**NOTICE OF ERROR
REPLY**

Water right number: 77-14140

77-14140

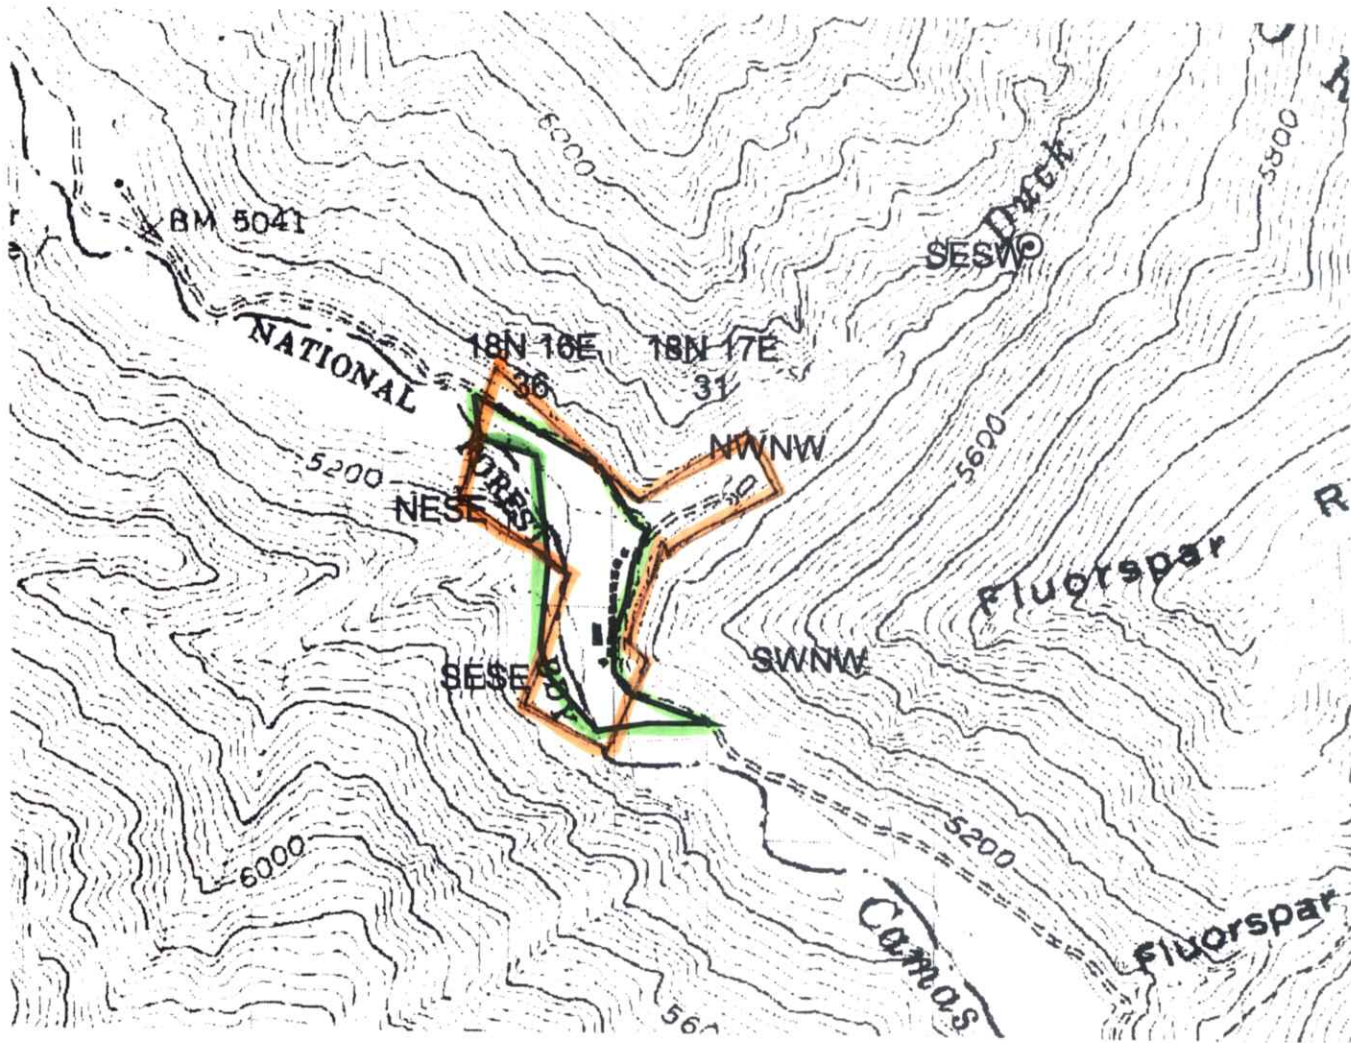
1. Describe the portion of the proposed recommendation with which you disagree (e.g. priority date, period of use, source): Point of Diversion: You have as the SE of SW of Section 30, T-18 N, R 17 E. This property is located on an unsurveyed section of Lemhi County. The area is also located at a Township & Range correction line. (See additional at bottom of page.)

2. Describe the changes you wish to make in the proposed recommendation:
Point of Diversion: I suggest you use a G.P.S. coordinate as a point of diversion. Place of Use: Use the mineral survey map #MS3548B recorded 4/28/83 as the place of use and not Section-Township & Ranges.
Map: See corrected map.

3. Give a brief explanation as to why you disagree with these portions:
The volume of water is correct; it is locations you have stated that may be in error. Use of MS3548B should clarify this.

1. (Continued from above) Place of Use: (Irrigation) As stated above in the Point of Diversion answer, you are using Quarter-Quarter descriptions which at the present time has not been surveyed. (Domestic) Same as Place of Use stated above.

Map: Prepared by Kenneth Knoblock dated November 30, 2005 does not show the complete irrigated area. Corrected map is enclosed.

Area as shown by
Kenneth Knoblock

Area of MS 3548 +
as irrigated
